TWIN BRIDGES SUBSTATION TRANSFORMER ADDITION

BID #2258-ADDENDUM #1, ACCEPTING BIDS TUESDAY, AUGUST 20, 2019

CITY OF ALEXANDRIA
ALEXANDRIA, LOUISIANA

SECTION
 DRILLED SHAFT L-1A.2
 1/2"=1'-0"
 (QUANTITY: 3)
 [INSTALLED BY OTHERS]

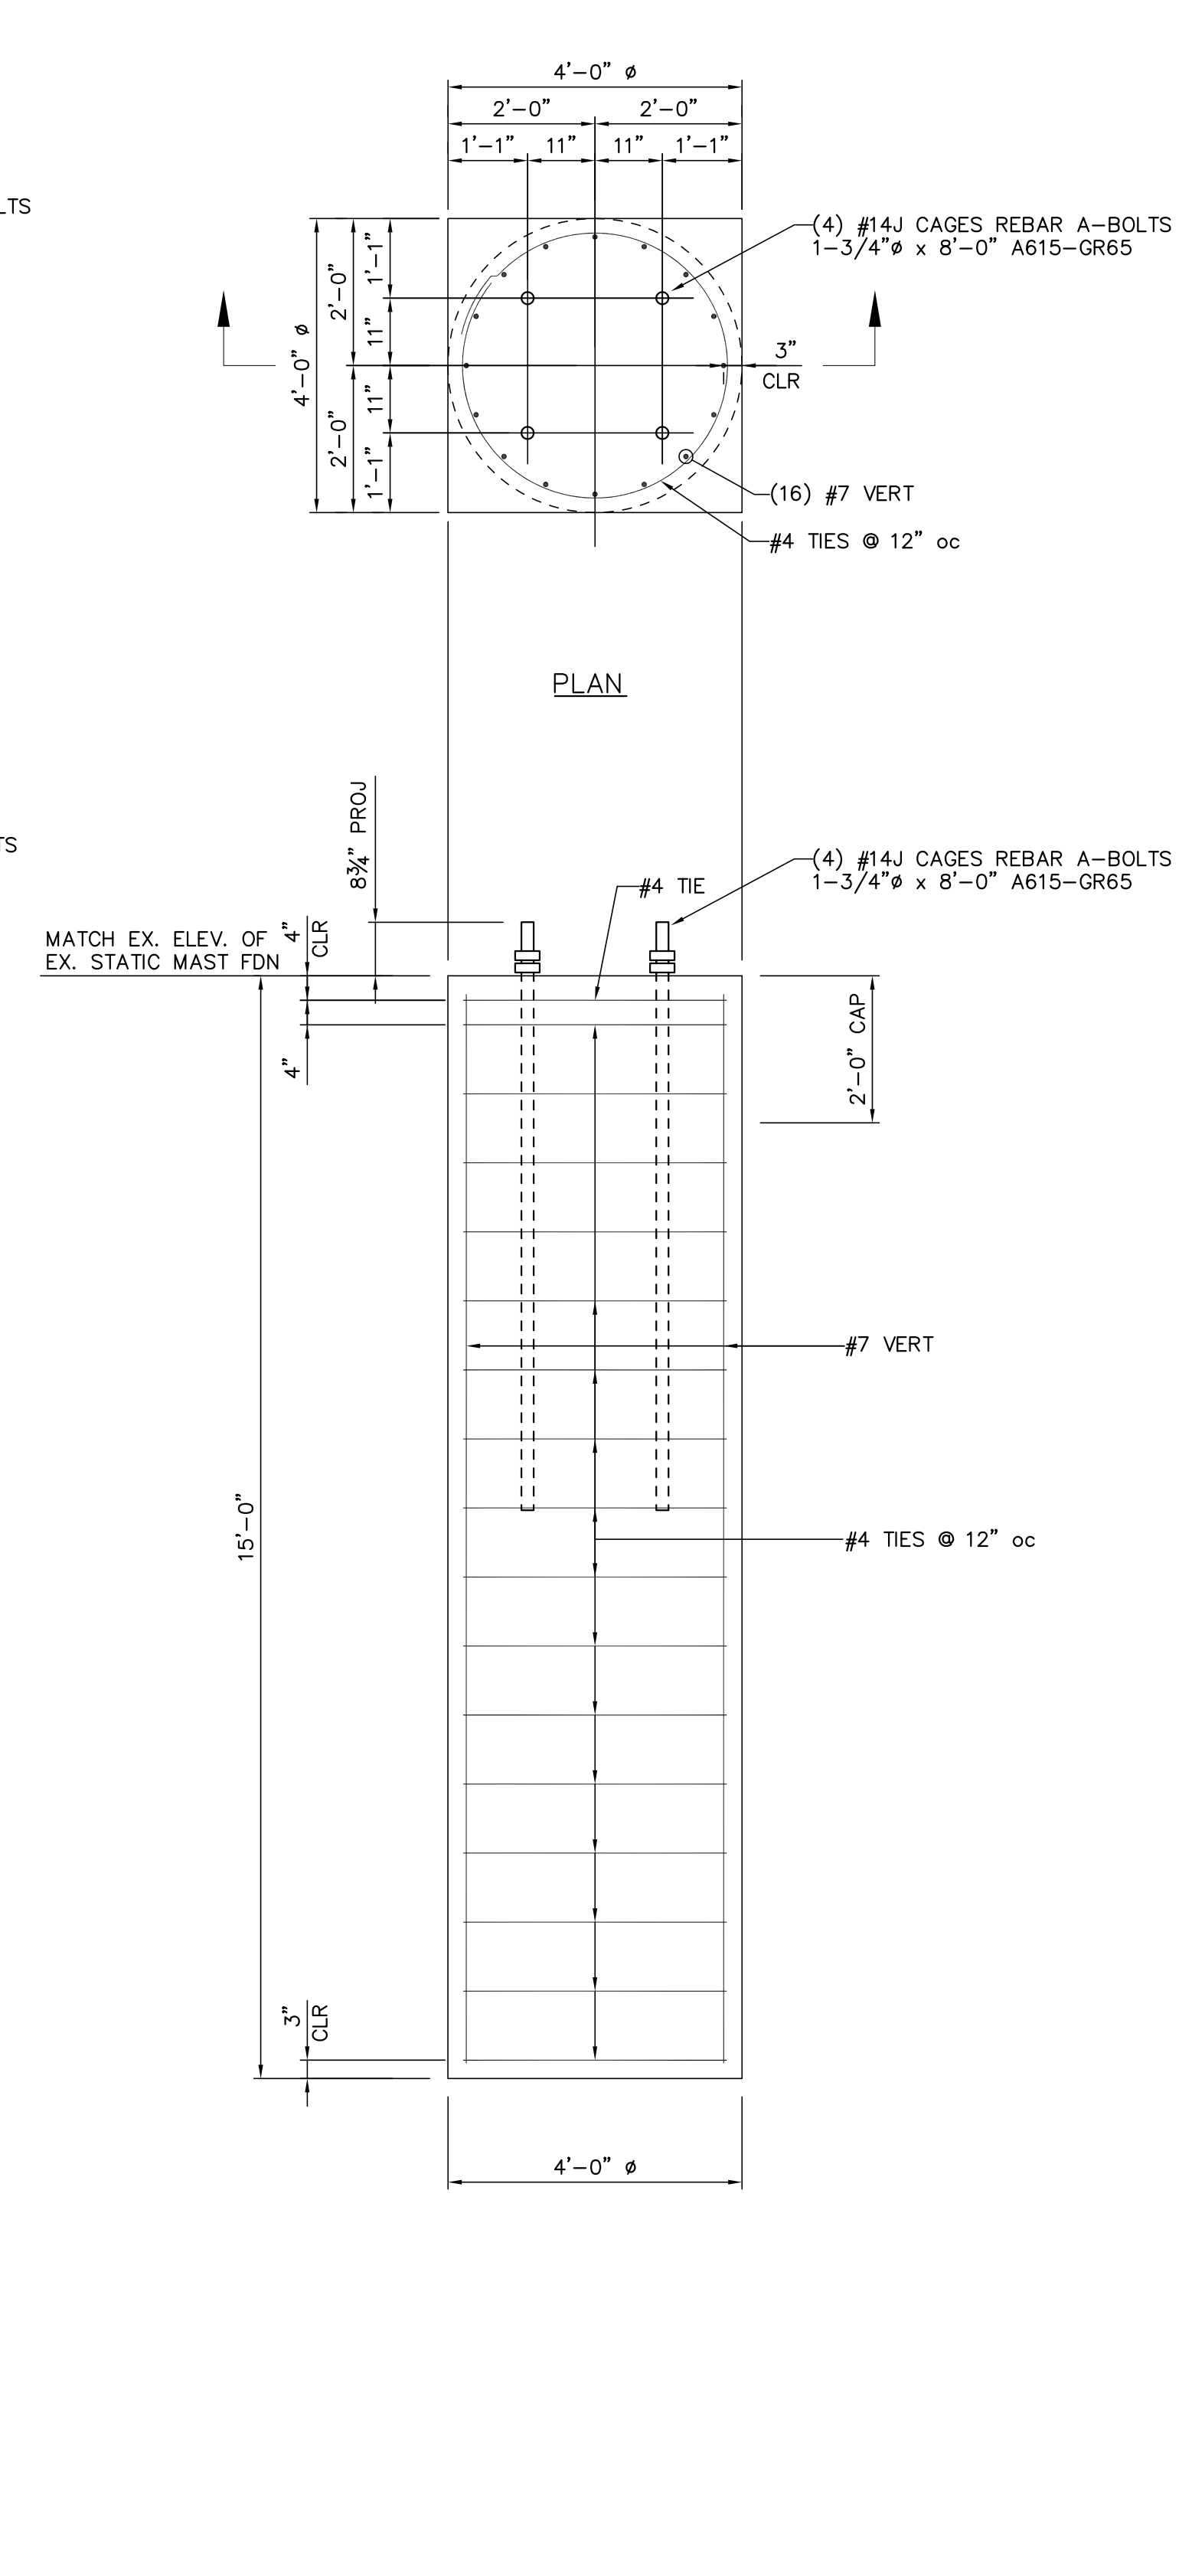
NO.	DATE	BY	REVISIONS
B2	6/24/19	BHA	REVISED DETAIL EW-1
B	5/30/19	BHA	FOR BIDDING PURPOSES ONLY
A	3/4/19	BHA	FOR BIDDING PURPOSES ONLY

**EXISTING CONTROL BUILDING
CONDUIT ROUTING LAYOUT**
SCALE: 1/2"=1'-0"

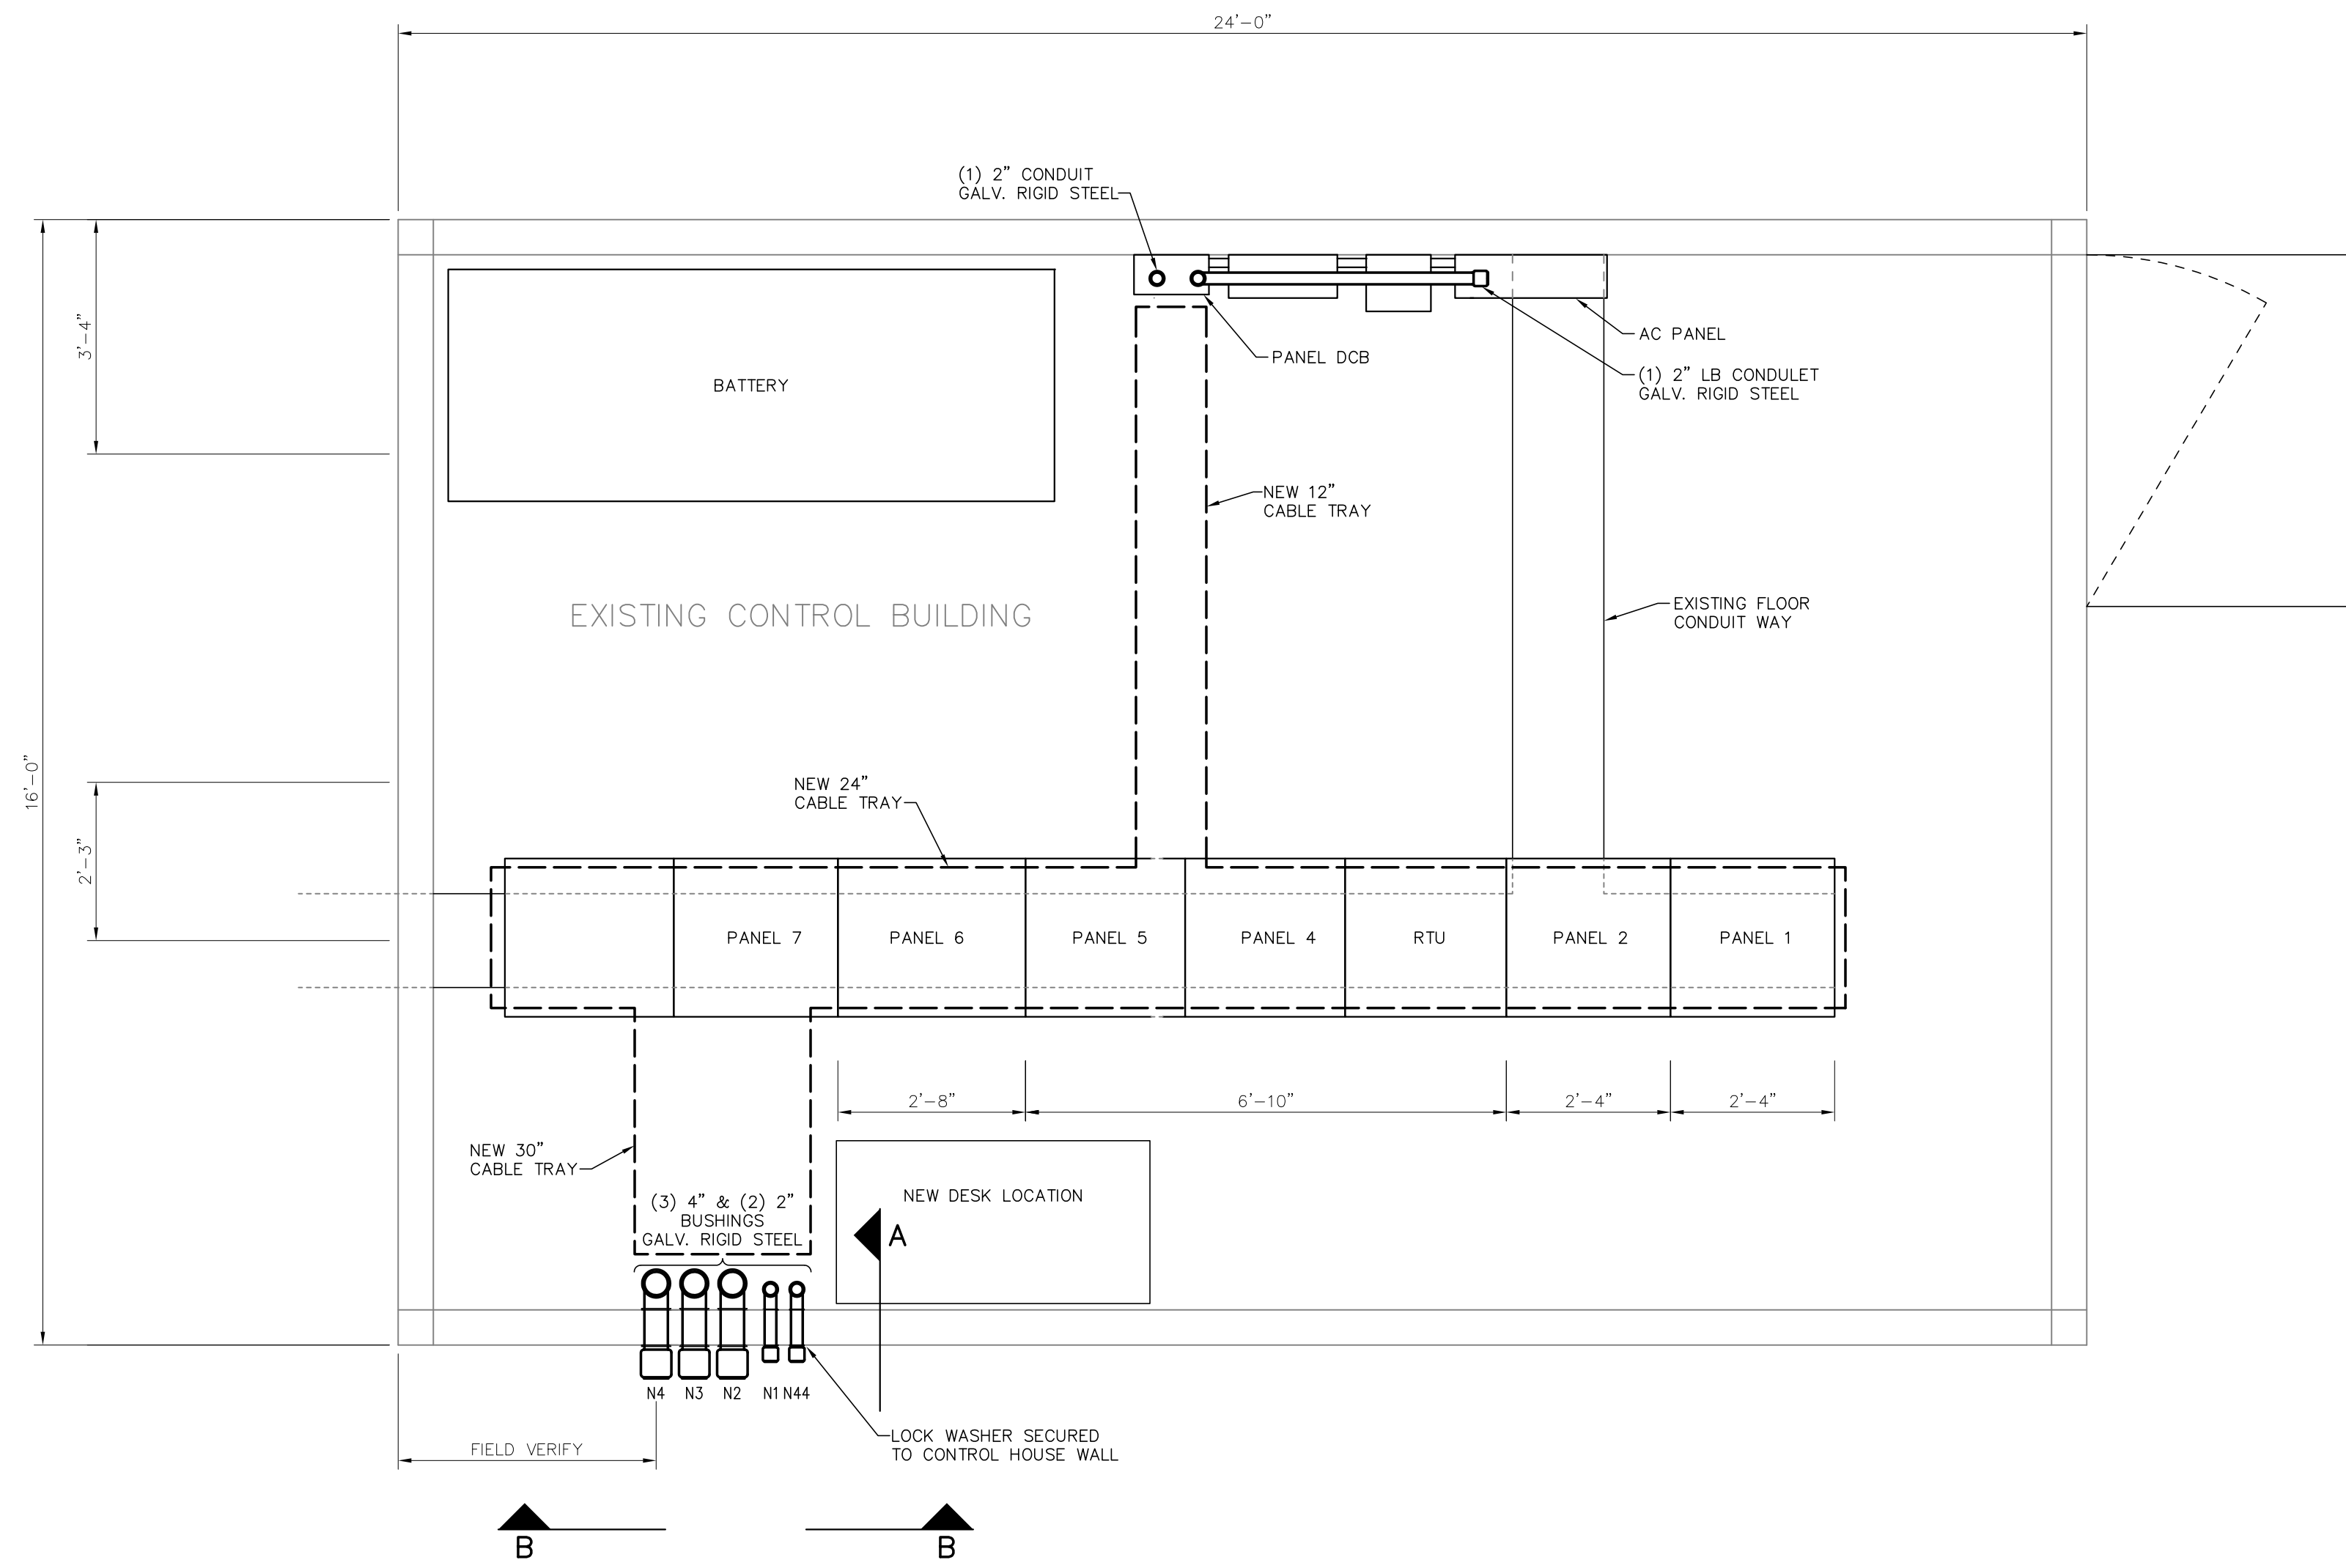
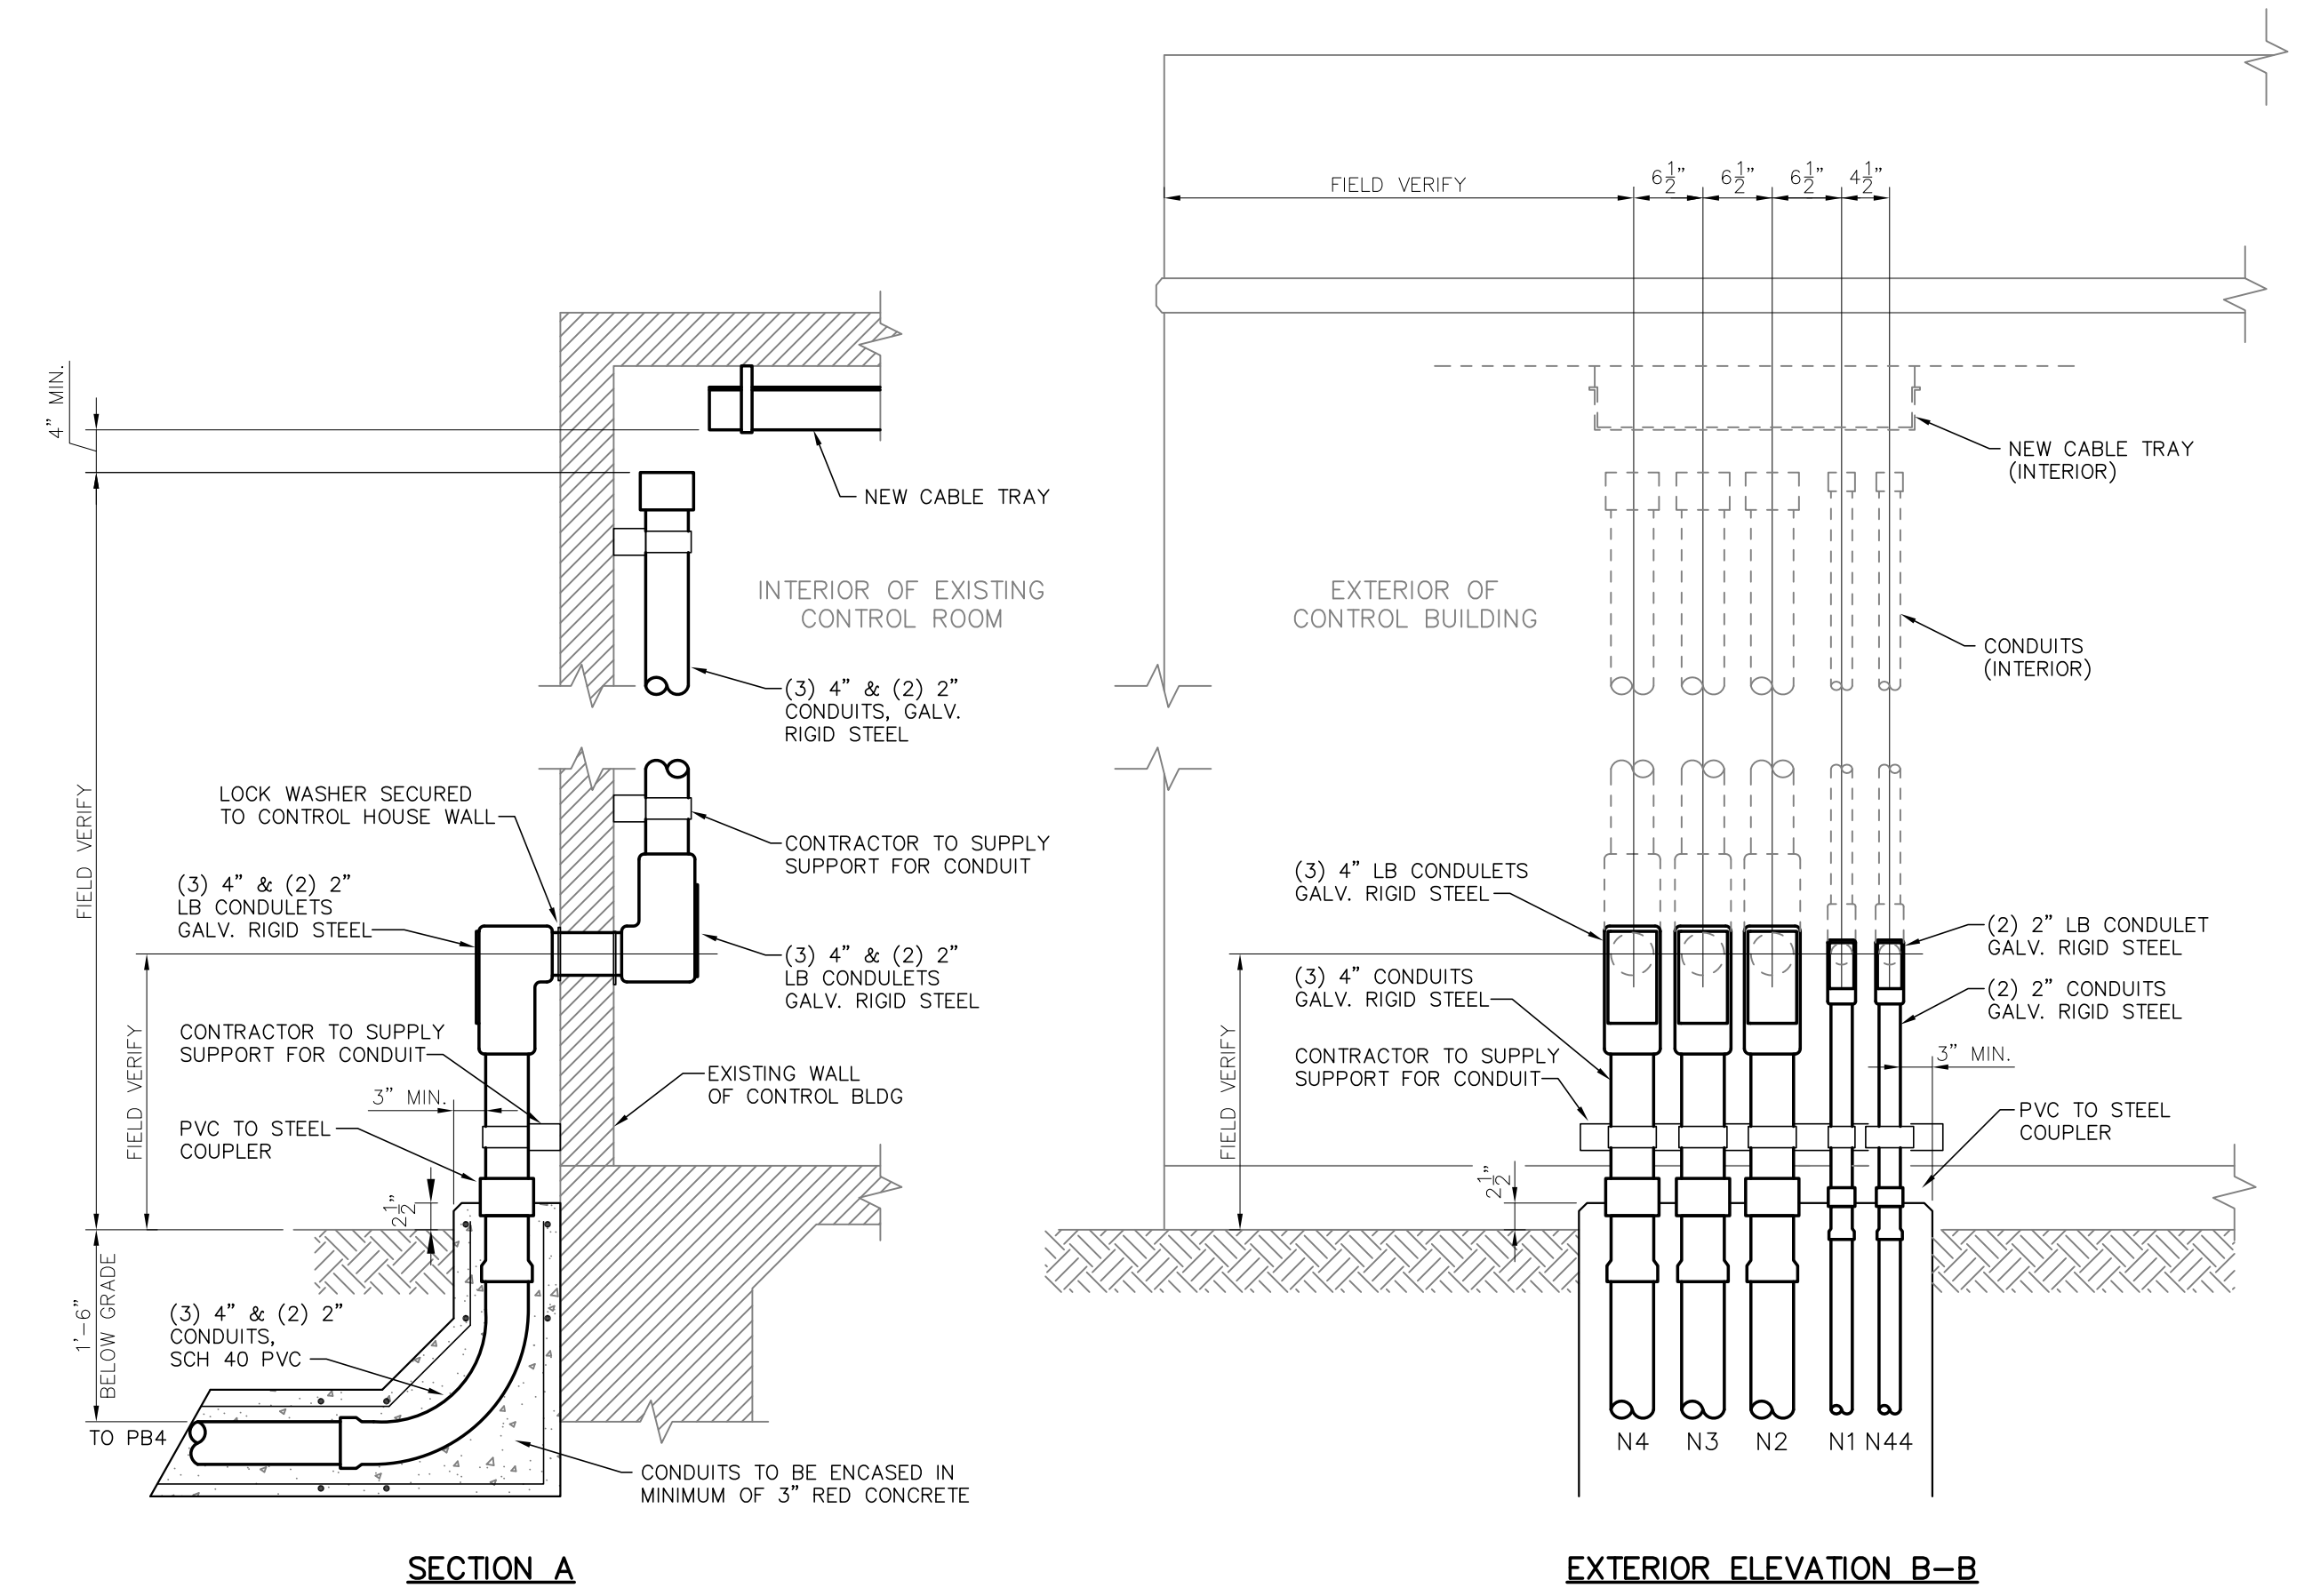
TWIN BRIDGES TRANSFORMER ADDITION EXISTING CONTROL BUILDING LAYOUT			
				CITY OF ALEXANDRIA ALEXANDRIA, LOUISIANA			
B2	6/24/19	BHA	REVISED CONDUIT ACCESS & ADDED CABLE TRAY	SCALE:	DATE:	DRAWN BY:	APPROVED BY:
B	5/30/19	BHA	FOR BIDDING PURPOSES ONLY - CONSTRUCTION	NOTED	2/5/19	TJW	JJC
A	3/4/19	BHA	FOR BIDDING PURPOSES ONLY - CONSTRUCTION	2019-E-16A			
				BHA, INC. BATON ROUGE, LOUISIANA		DRAWING NO.: TBTA-07B	
				REV.: B2
